NOTICE OF FILING

Palo Verde Unit 1 Shutdown Cooling Line Vibration Outage Review

October 3, 2007

GDS Associates, Inc.

Figure 2. Relocated SDC Suction Line Isolation Valve

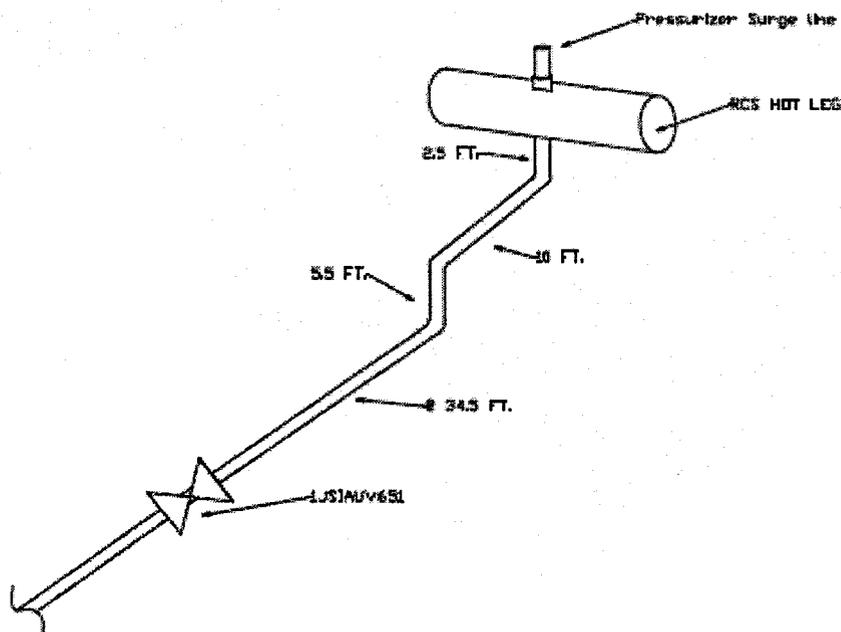
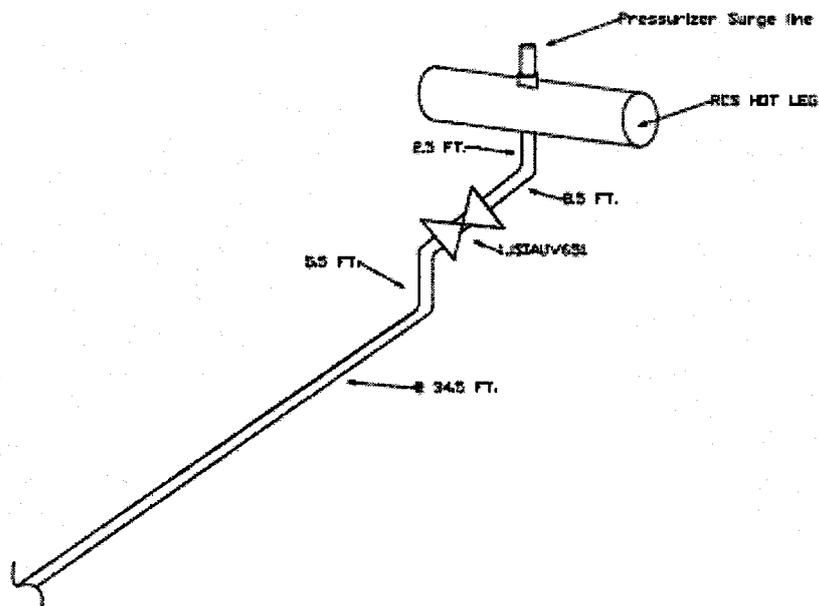
APS concluded that the vibration was flow induced and was caused by coupling between an excitation source, vortex shedding in the SDC line tee, and an acoustic resonator. The excitation source is the pressure disturbance resulting from the flow of reactor coolant across the tee joining the SDC suction line to the RCS hot leg. The acoustic resonator is the SDC suction line itself which forms a deep cavity bounded by the RCS hotleg on one end and the SDC suction isolation valve (1JSIAUV0651) on the other, a length of more than 50 feet. Facts supporting this determination include:

The root cause of the SDC suction line vibration was determined by APS to be a latent design weakness in that the configuration of the SDC suction line creates a resonator with a fundamental frequency close to the pressure disturbance at the SDC suction line tee.

The model testing demonstrated that moving the SDC suction line isolation valve would solve the problem. However, this modification was a complicated and lengthy process that involved significant engineering and procurement. Another promising approach was to modify the SDC suction line tee by installation of a grid plate. Scale model testing demonstrated that installation of a grid plate would be effective in reducing the acoustic pressure at the nozzle and the chosen design would not impact the functionality of the SDC system. The grid plate was installed during refueling outage 12. However validation testing following the refueling outage showed significant increases in surface vortexing and air entrainment which would make certain desirable modes of plant operation not feasible. Therefore, the grid plate was removed. With the failure of the grid plate modification, APS concluded that the best solution was to relocate the SDC suction line isolation valve.

Relocation of this valve was proposed by the consultants and the EPRI expert panel. Scale model testing showed a significant reduction in pressure amplitude and the acoustic frequency was shifted away from the vortex shedding and resonant pipe frequencies. The new location of the SDC suction line isolation valve SI-V651 is 11 feet from the RCS nozzle compared to the original location which was approximately 50 feet from the nozzle. This resulted in a higher acoustic frequency of 61 Hz compared to 25 Hz for the original location. The new configuration resulted in no significant coupling with the vortex shedding modes and no evidence of other significant excitation sources was identified. The new location is consistent with the location in some similar Korean System 80 plants. Most importantly, the modification was a success. No vibration issues were identified and vibration of the SDC suction line was well within acceptable limits. The new valve location approximately 11 feet from the hot leg is shown in Figure 2 below:

- Relocate Shut Down Cooling Valve SI-V651 from outside the Steam Generator compartment to inside;
- Re-route the 3-inch Reactor Coolant System Hot Leg Injection piping;
- Add on Missile Shield;
- Add one pipe whip restraint;
- Add several pipe supports;
- Relocate conduit;
- Install platforms;
